Technical Memorandum: Review of MW Proposed DSS for Casey Fields South (Employment) and Devon Meadows PSPs

Date: 31/03/2025
Project Number: 2101096, 2102129, 2300328
Project Name: Casey Fields South (Employment) & Devon Meadows PSP drainage strategy consultation
Authors: [REDACTED]
Reviewer: [REDACTED]
Version: 1

Location of Existing Flow Rate Measurements

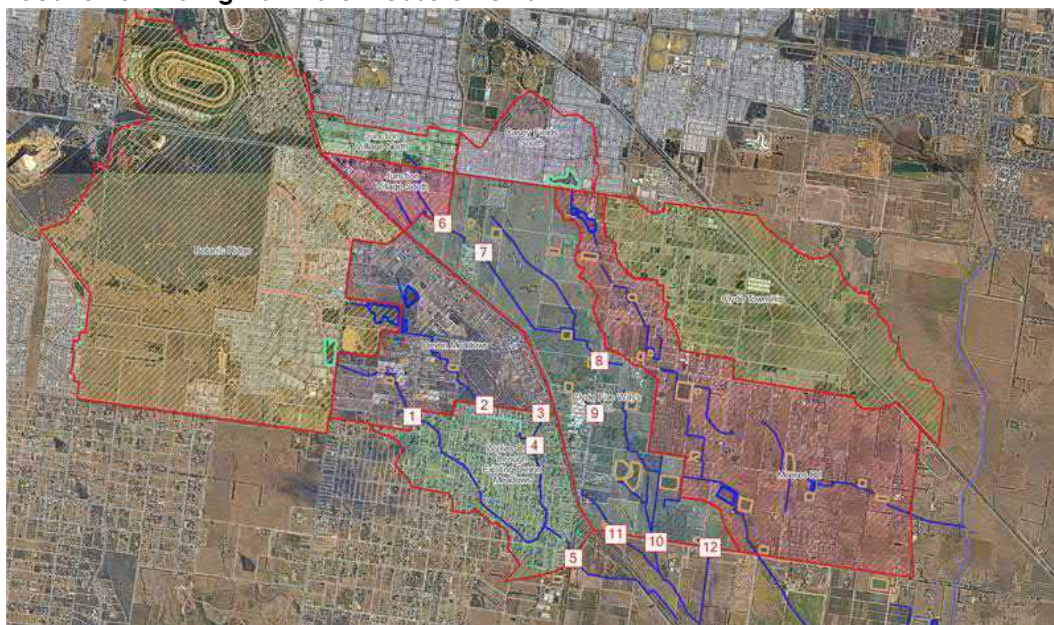
- Key locations are presented in the figure below with peak flow rates for critical storms presented in the table below. The results indicate that depending on the climate change assumption, flows could increase by approximately 50% (SSP2) or even up to 100% (SSP5).

Water Balance Model Preliminary Results

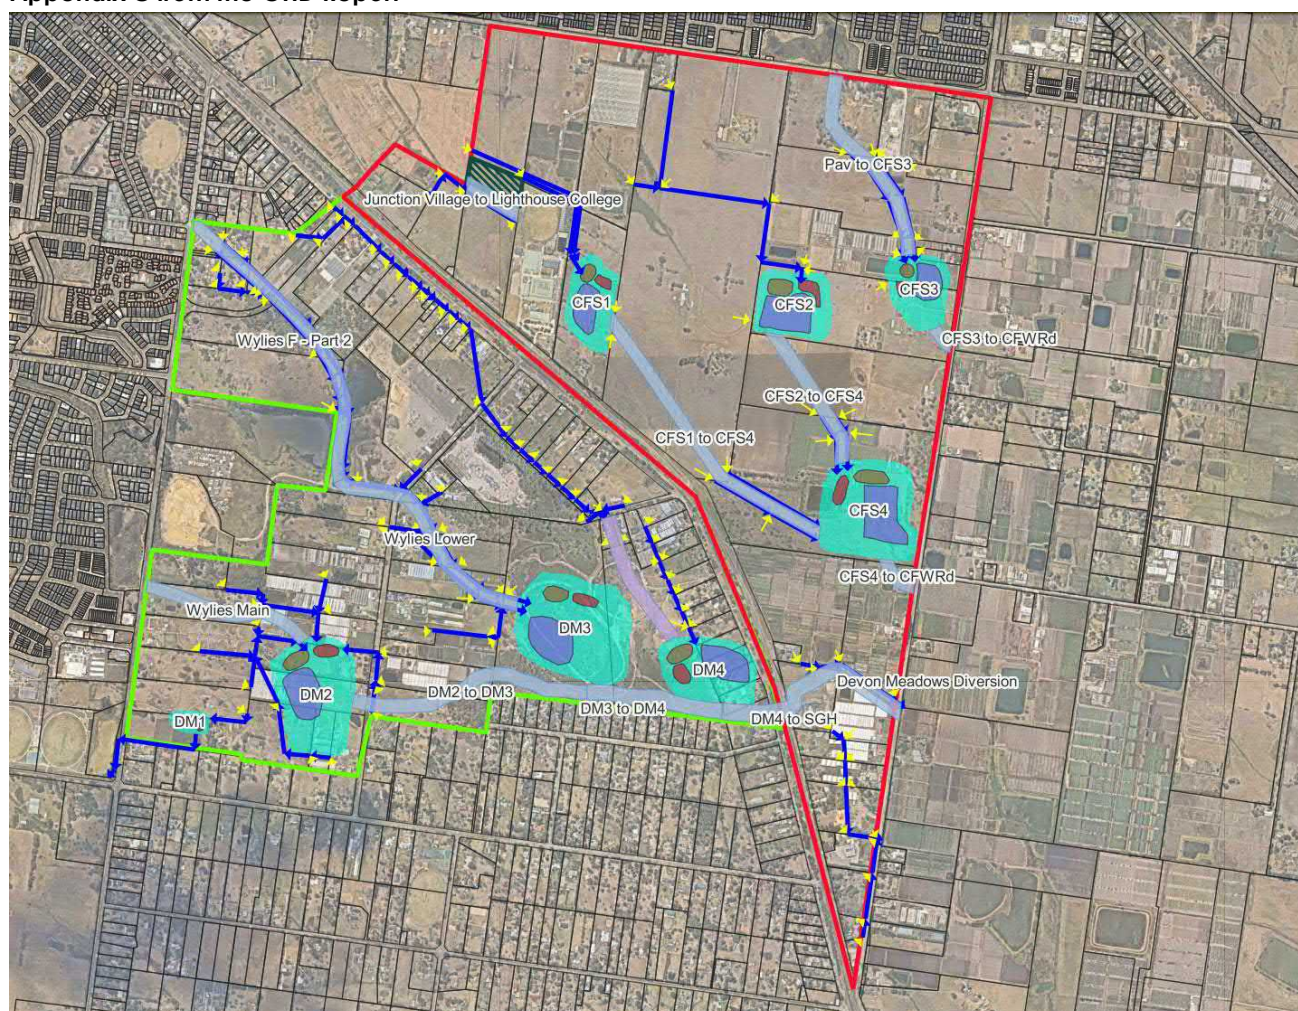
- The water balance modelling indicates that the development of Devon Meadows will increase the volumetric runoff by an average of 550 ML per year. As shown in calculations below, this volume would be enough to fill a large farm dam and could be conveyed under gravity by a single 225mm pipe.

- @DM2 using the means – 1335 ML/y – 1185 ML/yr = 150 ML/yr
- @DM3&4 using the means – 2048 ML/y – 1633 ML/yr = 415 ML/yr
- Therefore, total available excess volume from Devon Meadows is approx =565 ML/y
- This is enough to fill a single 2.8ha dam approx 2m deep every year, which is comparable to some of the larger farm dams downstream
- If this volume was conveyed under gravity a flow rate of approx 18 L/s would be required, which could be conveyed in a single 225mm pipe at 0.5% grade (capacity approx 32 L/s)

- retarding basins to ensure pre-development flow rates at the boundary
 - capture and retention of ~565 ML/y of flows in the basin and a diversion pipe in the order of 225mm to direct it to the farmland downstream for re-use

Long Section of the Diversion Channel Between DM2 and DM3

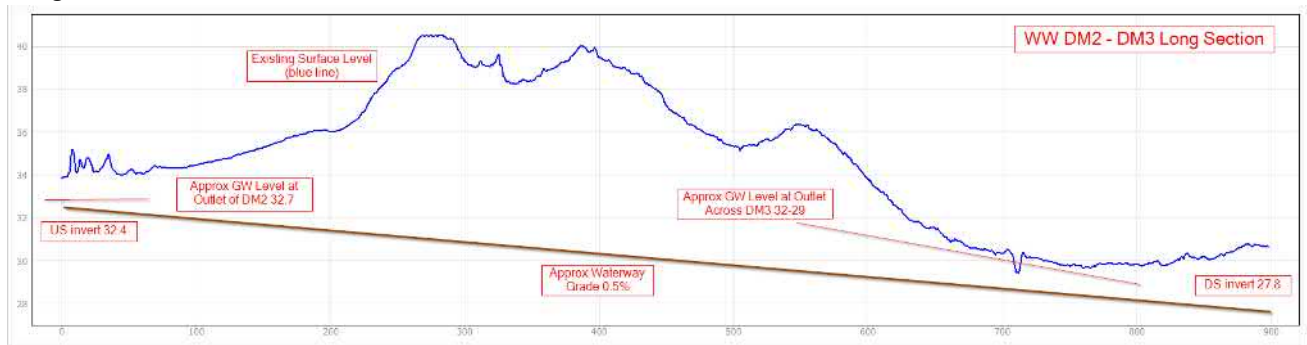
- BW have used the 1m LiDAR and levels summarised in GHDs report to try and understand how the channel works with the terrain and groundwater levels.
 - Preliminary analysis indicates that the diversion channel requires significant cut to achieve the required levels, particularly between basins DM2 and DM3.

- At its deepest, up to 10m of cut will be required which, with the proposed 1:5 batters, could require a reserve width of up to 100m at its widest rather than the 45m shown on GHDs concept plan. This would require a significant volume of earthworks to achieve with the associated significant cost.

- When compared with GHD's groundwater observations, it appears that significant sections of the channel are proposed to be below the groundwater level which raises several key issues:

the perceived issue, instead just relocating it to a different location. We recommend abandoning the diversion channel proposal and focusing on a different solution to protect homes in Devon Meadows.

Northern Crossing (CFS3 to CFWRd)

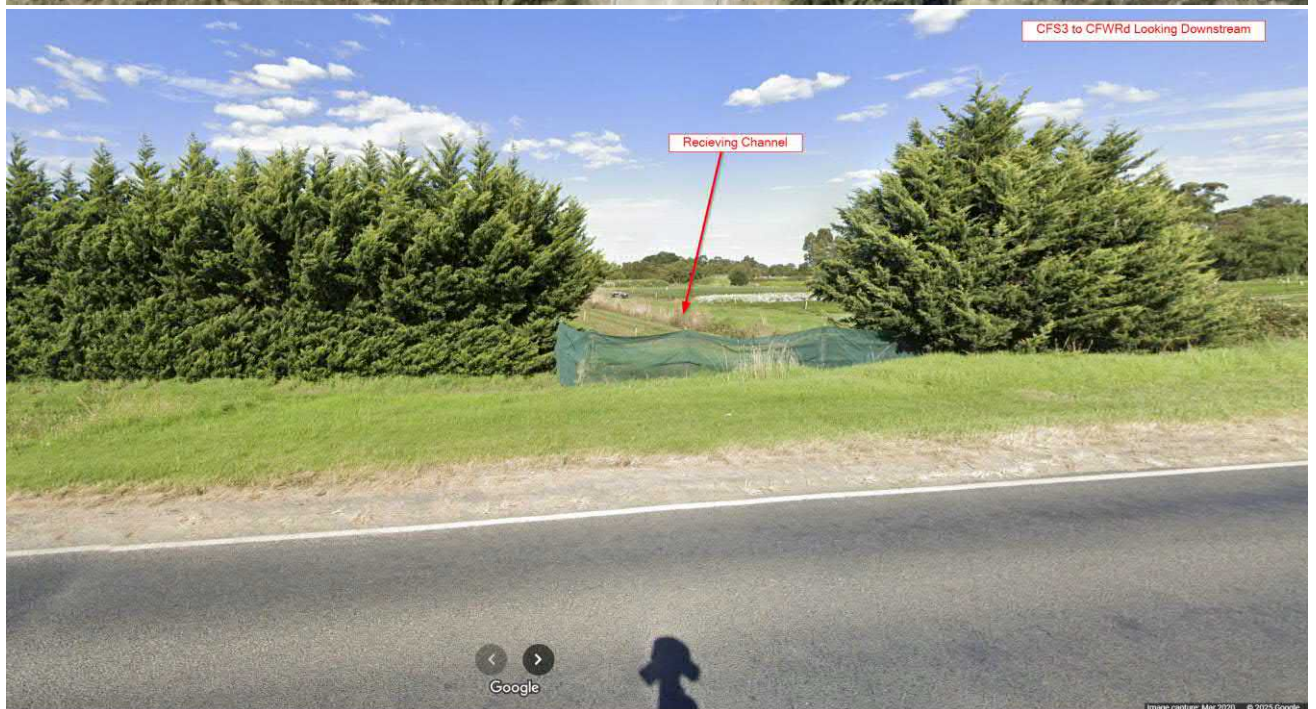
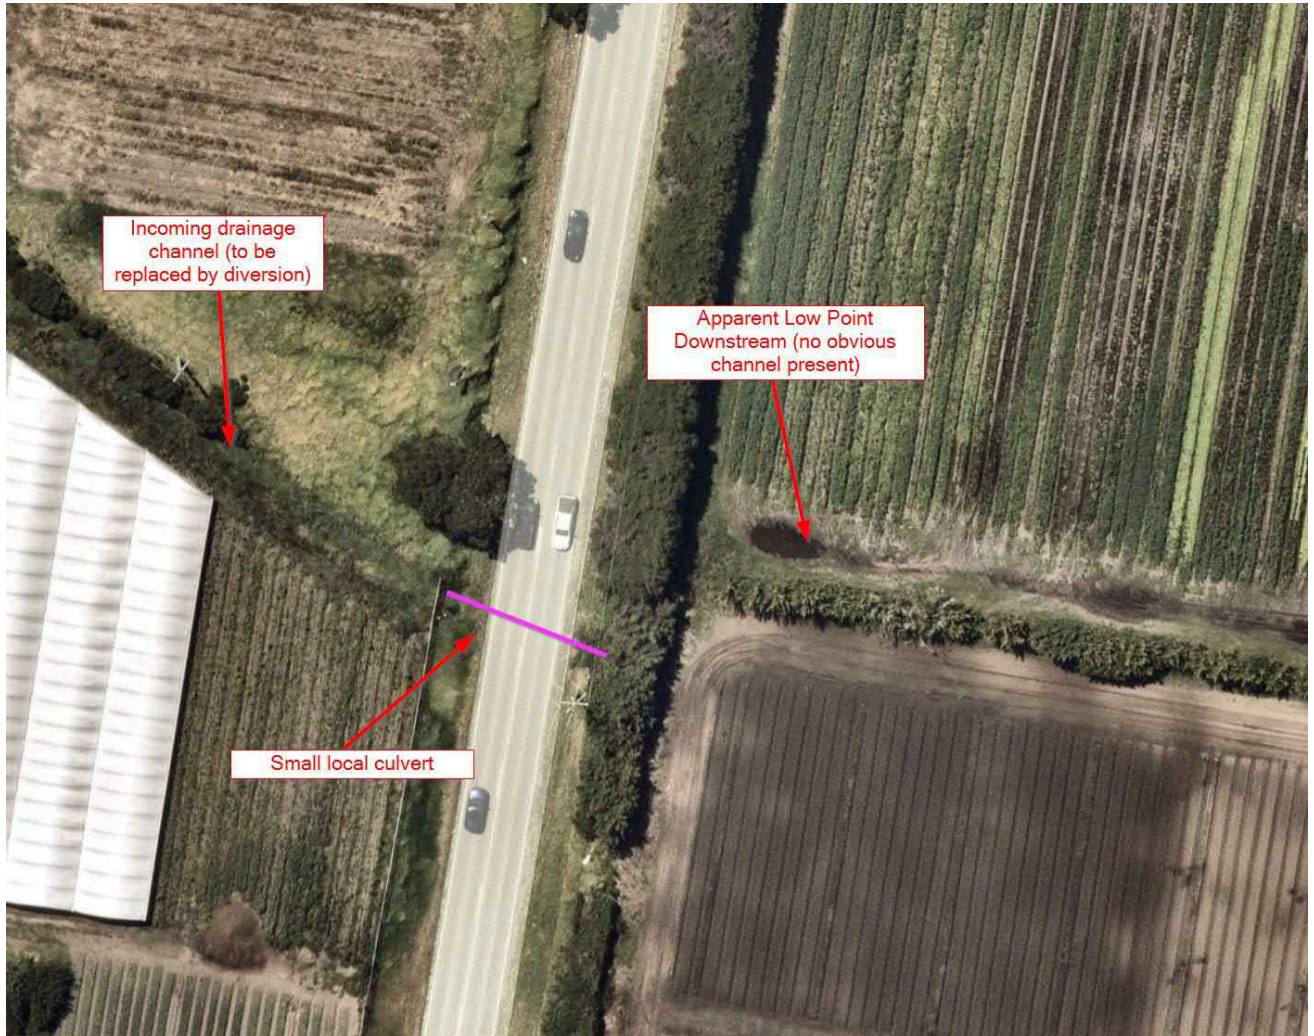
- **Connection Points and Impact to Landowners in Clyde South**
 - At this time, the proposed strategy relies on 3 connection points (shown in images below)

- These points are characterised by:
 - Roads being only marginally above the surrounding floodplain
 - An absence of any major drainage features, which are at best a small drainage channel and culvert and at worst no drainage feature at all

- The following is unclear:
 - How the proposed connections will work:
 - What will they connect to where no channel exists, will there be a requirement to extend the channel until an appropriate discharge point is reached?

- Is it proposed to lower the channel or raise Clyde Five Ways Rd to construct sufficient culvert crossings?
 - How will these works impact the existing landowners

- We would recommend that further analysis be undertaken to address the above questions prior to adoption of the proposed strategy.

- **The Devon Meadows Retarding Basins**

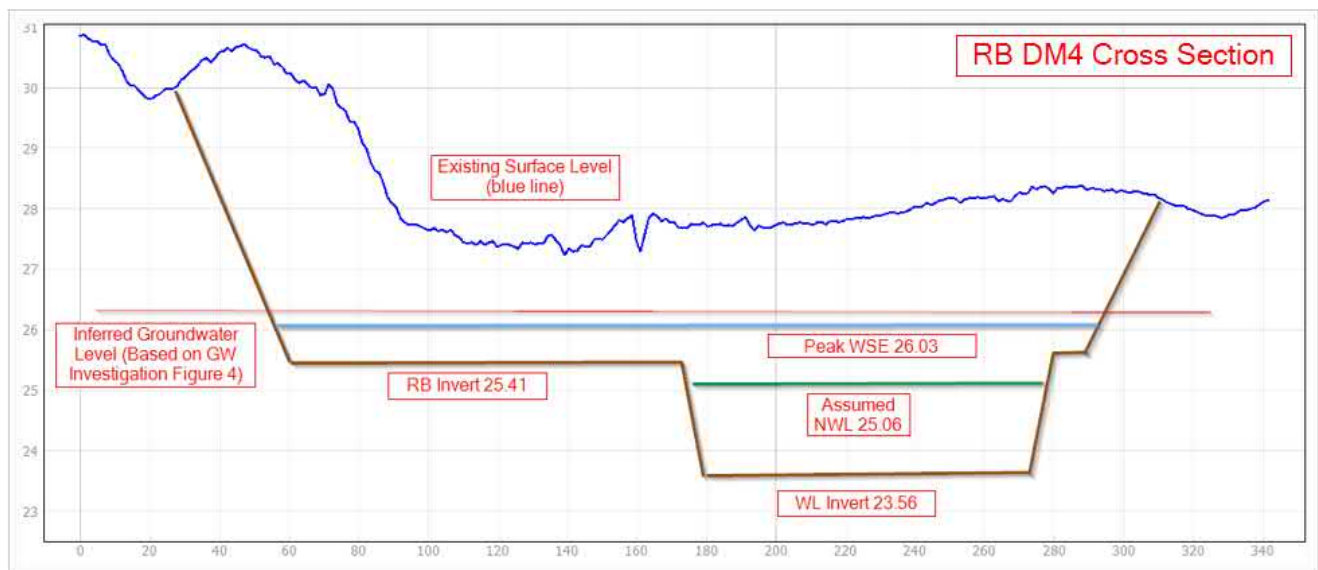
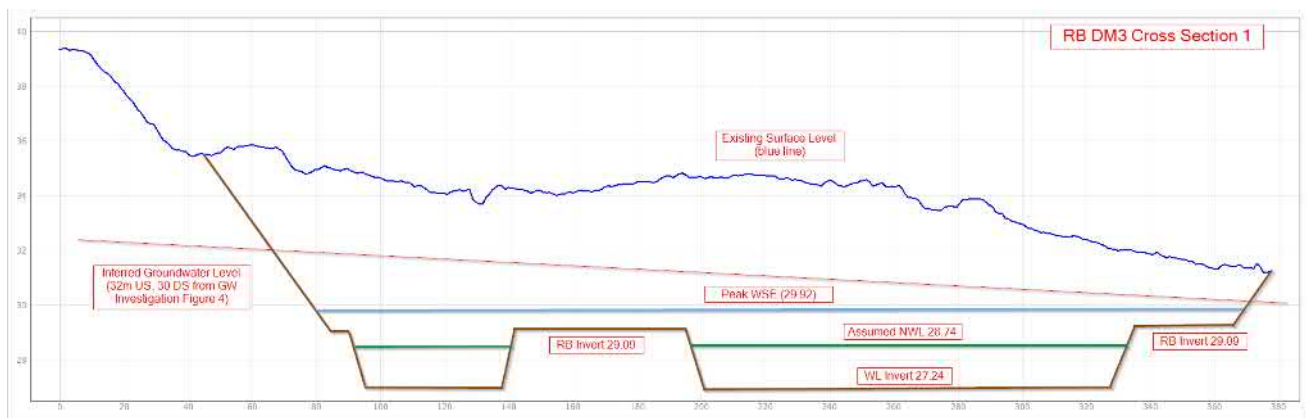
- BW have used the 1m LiDAR and levels summarised in GHDs report to try and understand how the basins work with the terrain and groundwater levels.
- Analysis indicates that these basins are proposed to be cut deep, as much as 5m in the ground and well below the estimated groundwater level.
- Despite their extreme depth, the proposed storage height of water in the retarding basin is relatively shallow (typically 0.6m-1.2m in the 1% AEP) leading to relatively large footprints/land take by the basins
- This is not feasible or realistic and these basins need to be redesigned.

- Redesign of the Devon Meadows basins to demonstrate that objectives can be met without the need to divert to Clyde South
 - Concept design of works downstream of Clyde Five Ways Rd to allow MW and the VPA to arrange a PAO to secure outfalls for Casey Fields
